Z-28
(2013)

PROJECT NAME:
4305 & 4306 SANDY PLAINS
SUBDIVISION

PETITION NO: Z-28

ZONING COMMENTS:

DRAWING TITLE:
ZONING PLAN
DRAWING NUMBER:
01
PLOT DATE: 4/11/13

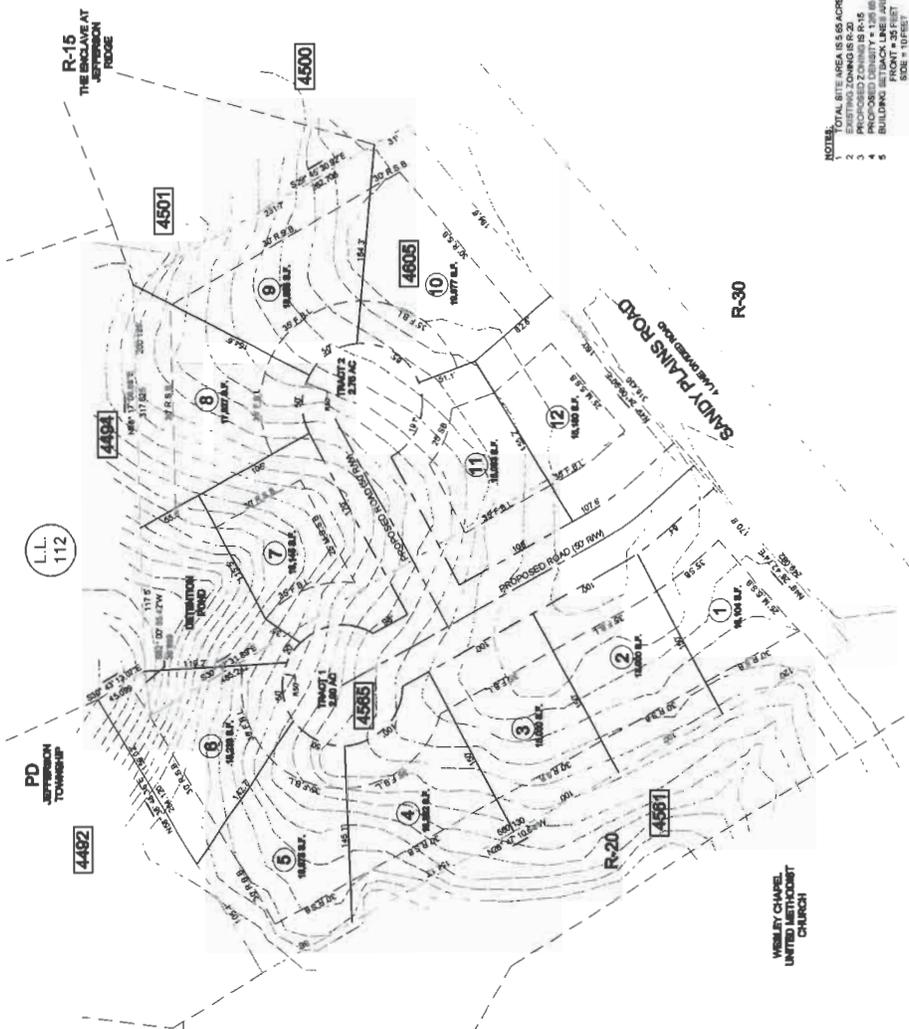
- Provide comprehensive hydrology/stormwater controls to include development of out parcels.
- Submit all proposed site improvements to Plan Review.
- Any **spring activity** uncovered must be addressed by a qualified geotechnical engineer (PE).
- Structural fill _____ must be placed under the direction of a qualified registered Georgia geotechnical engineer (PE).
- Existing facility.
- Project must comply with the Water Quality requirements of the CWA-NPDES-NPS Permit and County Water Quality Ordinance.
- Water Quality/Quantity contributions of the existing lake/pond on site must be continued as baseline conditions into proposed project.
- Calculate and provide % impervious of project site.
- Revisit design; reduce pavement area to reduce runoff and pollution.

- No Stormwater controls shown _____
- Copy of survey is not current – Additional comments may be forthcoming when current site conditions are exposed.
- No site improvements showing on exhibit.

1. This parcel is located to the west of Sandy Plains Road. The majority of the site drains to the north directly into the Jefferson Township subdivision through two large lots. There is a natural drainage way leading to an existing 48-inch CMP private drive culvert, but no well-defined channel. A level spreader may be required for the proposed detention pond to lessen the impact of a concentrated discharge.
2. A drainage swale and easement will likely be required along the rear of lots 1-5 & possibly lot 8 to limit offsite runoff bypass.
3. A pre- and post-development sediment survey will be required for the downstream private pond.

Sandy Plains Road is classified as an arterial and according to the available information the existing right-of-way does not meet the minimum requirements for this classification.

Recommend applicant consider entering into a development agreement pursuant of O.C.G.A. 36-71-13 for dedication of the following system improvements to mitigate traffic concerns: a) donation of right-of-way on the north side of Sandy Plains Road, a minimum of 50' from the roadway centerline.

Recommend curb and gutter along both sides and sidewalk along one side of proposed development roadway.

Recommend a deceleration lane on Sandy Plains Road for the entrance.
